Access Compliance Report

Public Rights-of-Way

(Curb Ramps)

Intersection ID: 13683	Main Street: ELIZABETH_AV	Cross Street: CHARLOTTETOWNE_AV	Location: S
ADA ID: BAE82241B9B1	Ramp Type: Perp	Initial Pass/Fail: Fail	Overall Compliance: No
Severity Score: 10			
Codes/Mitigation Info/Possible Solution		Field Measurements/Component Compliance

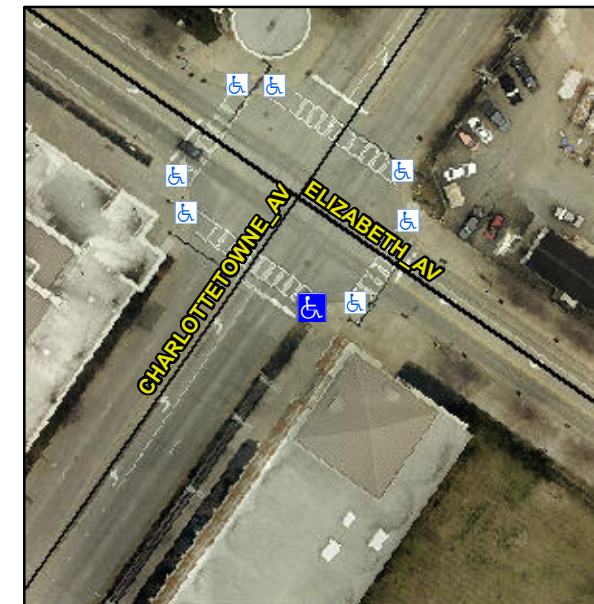
Not Found, R304.5.1, R304.5.3

Compliance	Description	Data	Compliance	Description	Data
N/A	Ramp Length (in)	84.0	Yes	Ramp Slope (%)	8.0
No	Ramp Width (in)	47.5	No	Ramp XSlope (%)	3.1
N/A	Flare Type LT	N/A	N/A	Flare Type RT	N/A
N/A	Flare Slope LT (%)	N/A	N/A	Flare Slope RT (%)	N/A
N/A	Flare Traversable LT?	N/A	N/A	Flare Traversable RT?	N/A
N/A	Landing Length (in)	N/A	N/A	DWS Provided?	N/A
N/A	Landing Width (in)	N/A	N/A	DWS Contrast?	N/A
N/A	Landing Slope (%)	N/A	N/A	DWS Length (in)	N/A
N/A	Landing X Slope (%)	N/A	N/A	DWS Full Width?	N/A
N/A	Landing Curb? (Y/N)	N/A	N/A	DWS Offset (in)	N/A
N/A	Shared Landing?	N/A			
N/A	Gutter Ponding?	N/A	N/A	Gutter Slope (%)	N/A
N/A	Gutter Lip Ht (in)	N/A	N/A	Gutter X Slope (%)	N/A
N/A	Painted X Walk1?	Yes	N/A	Painted X Walk2?	N/A
	X Walk 1 Direction	To NW		X Walk 2 Direction	N/A
N/A	X Walk 1 Width (in)	106.0	N/A	X Walk 2 Width (in)	N/A
	X Walk 1 Slope (%)	4.4		X Walk 2 Slope (%)	N/A
	X Walk 1 X Slope (%)	1.7		X Walk 2 X Slope (%)	N/A

Remove & Replace Entire Ramp.
